Subject: USNRC Docket No. 71-9261; TAC No. L22085  
HI-STAR 100 Transportation CoC 9261  
License Amendment Request 9261-1, Supplement 2

Enclosures: 1. Replacement SAR page 2.R-7, proposed Revision 9 (1 page)  
2. QUAD+ Criticality Model Sketch (1 page)  
3. Mark-ups of CoC 9261, Appendix A (2 pages)

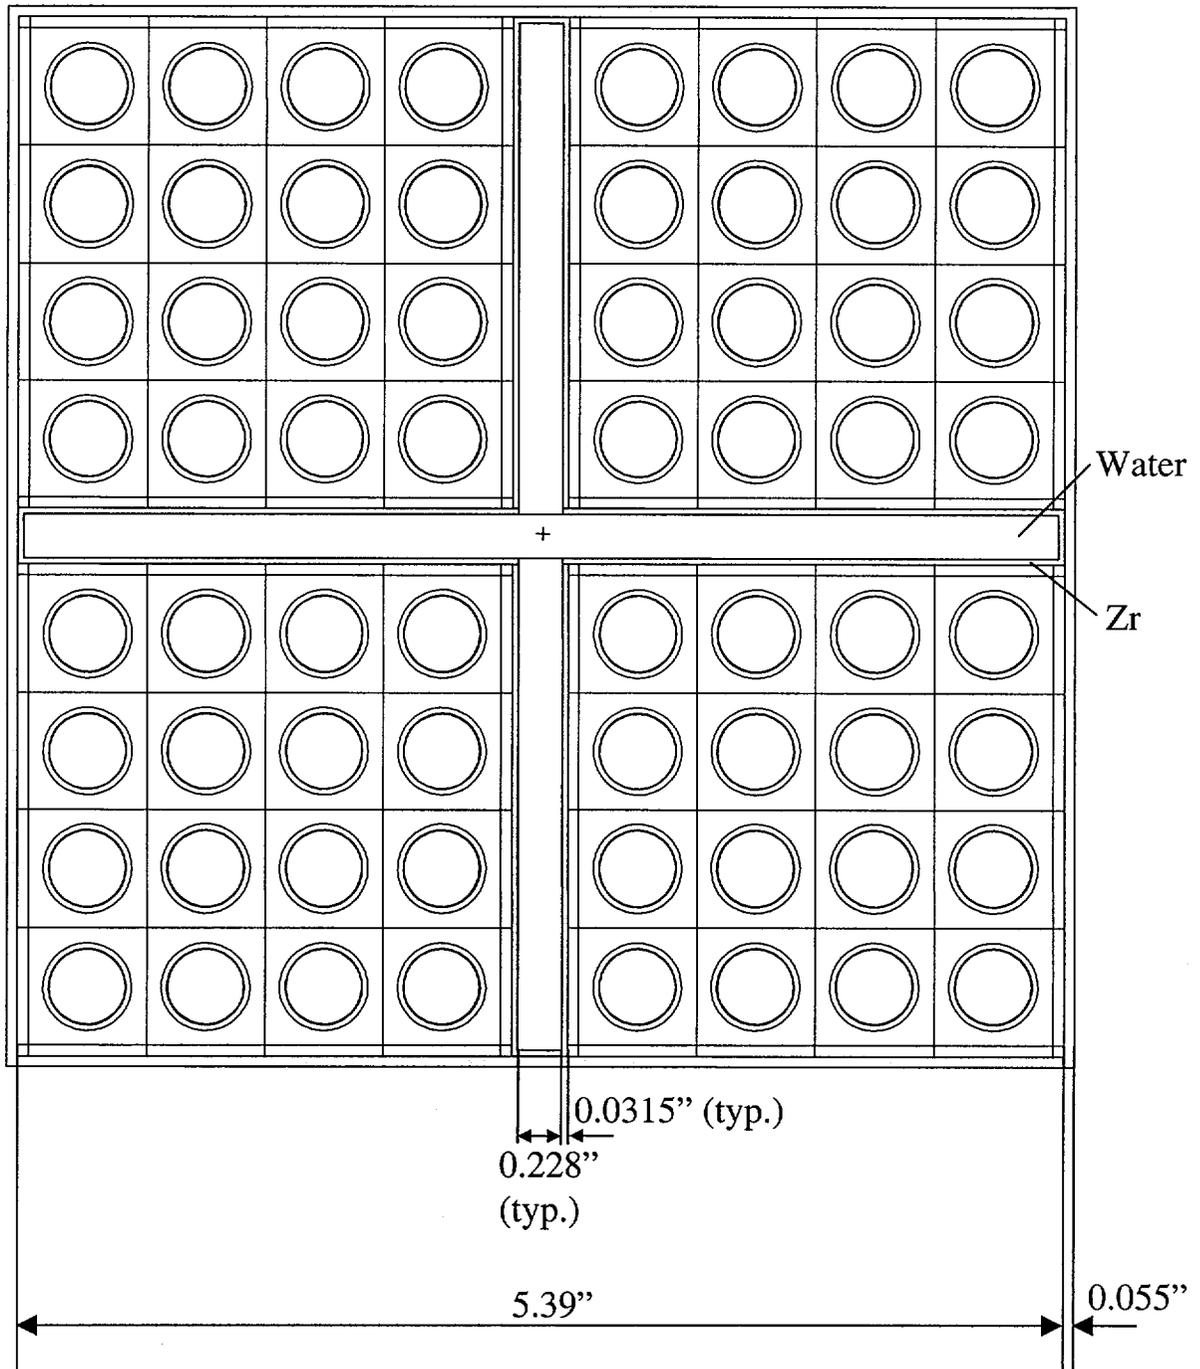
As committed during our telephone conversation yesterday, we enclose herewith replacement pages for proposed Safety Analysis Report (SAR) Revision 9, a sketch of the criticality model of the QUAD+ assembly, and revised wording for the Certificate of Compliance related to the Antimony-Beryllium neutron source. Please note that while the value of  $S_{by}$  presented in Appendix 2.R is different due to a unit conversion, the value used in the underlying calculation is unaffected and the 33% safety margin remains unchanged.

The direct shear force/unit throat thickness is determined as:

$$t_{\text{req}} := \frac{S_{eq}}{\sigma_y} \qquad t_{\text{req}} = 3.187 \text{ in}$$
